Lake Powell Pipeline Project
FERC Additional Information Request Schedule B – Item 19

Exhibit E

Recreation Resources

**Hurricane Cliffs Area
Recreation Impacts**

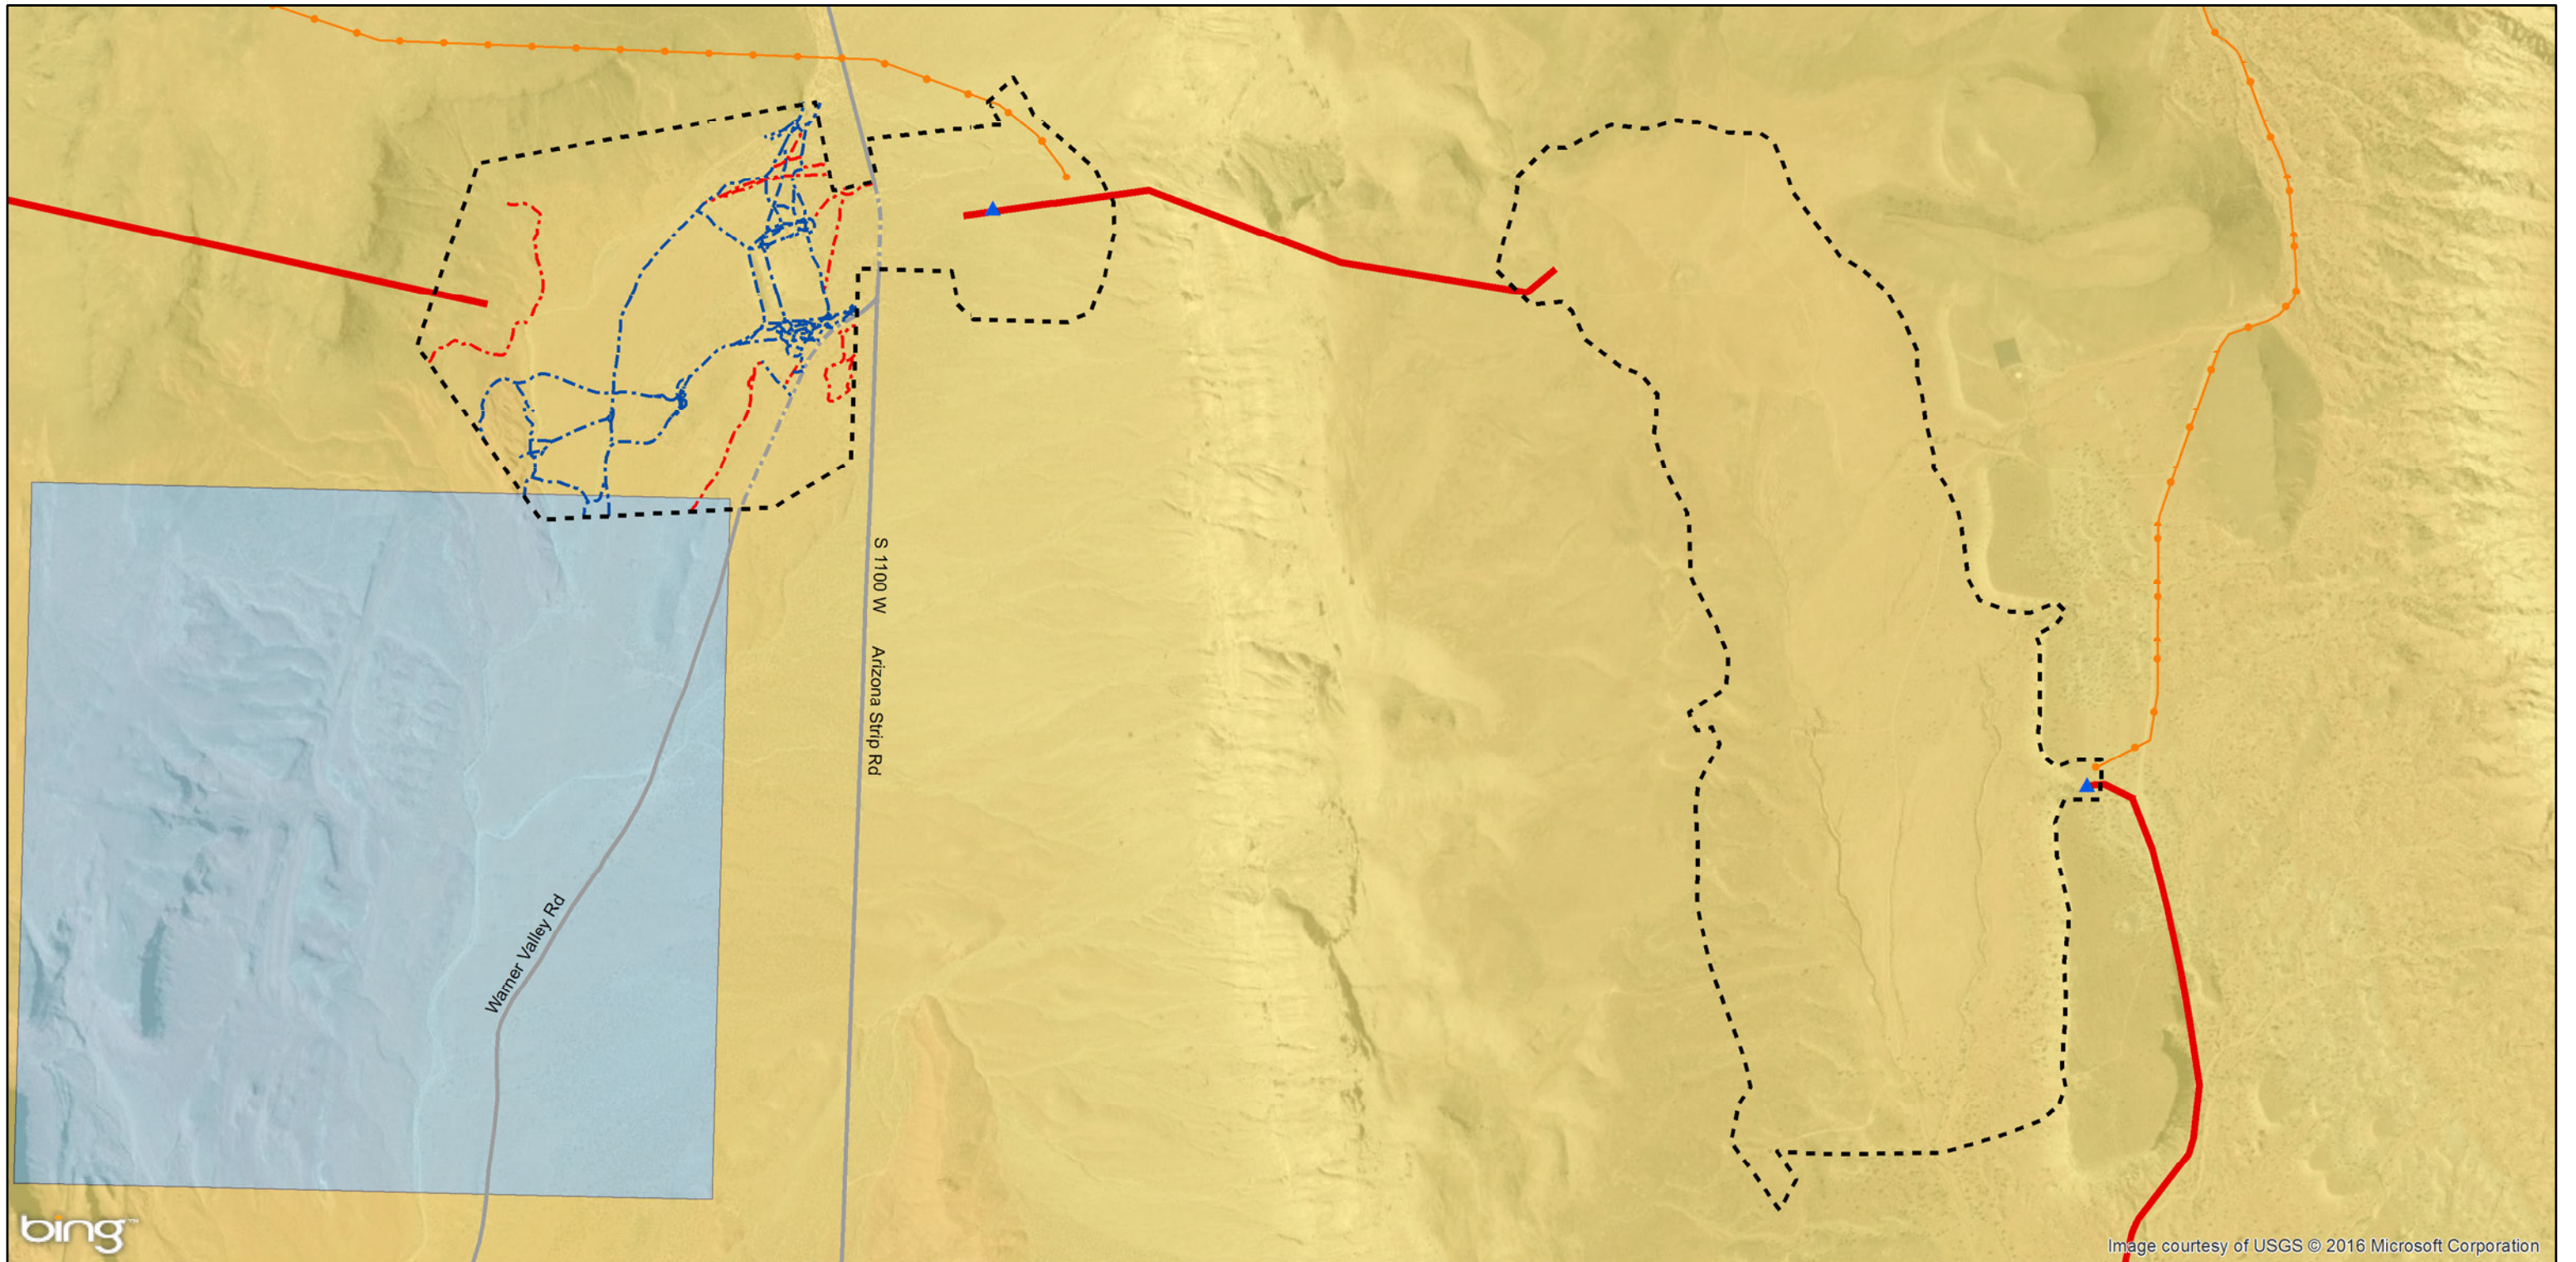
- 19. Final Study Plan 9, *Recreation Resources*, requires you to use field reconnaissance methods and secondary data sources to develop an inventory of facilities in proximity to the proposed project and to analyze use patterns at recreation sites that would be affected by the proposed project. We were not able to locate the inventory and analysis in Final Study Report 9 and exhibit E lacks the majority of recreation sites that may be affected by the proposed project. Please provide an inventory that includes each site that would be affected by the proposed project, as required by the approved study plan. The inventory and analysis should identify and quantify the land, reservoir surface area, and all facilities (including dispersed sites and the number and lengths of any trails) that would be removed from recreation use. In addition, please provide a detailed map showing the lands proposed to be removed and the affected recreational facilities.**

A portion of the Sand Mountain SRMA, administered by the BLM St. George Field Office, would be permanently removed by construction and operation of the Hurricane Cliffs Hydroelectric Power Station tailrace channel and afterbay reservoir. The Sand Mountain SRMA has a total surface area of 20,709 acres. The proposed LPP project would permanently affect 192 acres of land area in the Sand Mountain SRMA. The proposed afterbay reservoir and tailrace channel surface area within the Sand Mountain SRMA would total 136.2 acres. Two segments of BLM roads, and dispersed use, user-defined trails and ATV roads, are the only recreation

features within the Sand Mountain SRMA that would be permanently removed from recreation use by the proposed LPP project. There are no existing marked trailheads, formal parking areas, restroom facilities, or information kiosks with maps or other information within the portion of the Sand Mountain SRMA that would be permanently removed by the proposed LPP project. The two segments of BLM road that would be removed from recreation use include 657 feet of BLM road crossed by the proposed tailrace channel and 1,724 feet of the BLM Warner Valley Road. Fourteen dispersed use, user-defined trails totaling 8,824 feet long would be permanently removed from recreation use by the proposed LPP project. Seven of the dispersed use, user-defined trails are under 200 feet long. Eighty-one dispersed use, user-defined ATV roads totaling 25,217 feet long would be permanently removed from recreation use by the proposed LPP project. Forty-nine of the dispersed use, user-defined ATV roads are under 200 feet long. Figure 2-1 shows the BLM and State of Utah lands proposed to be removed by the LPP project and the affected recreational roads and trails (shown within the Proposed FERC Project Boundary).
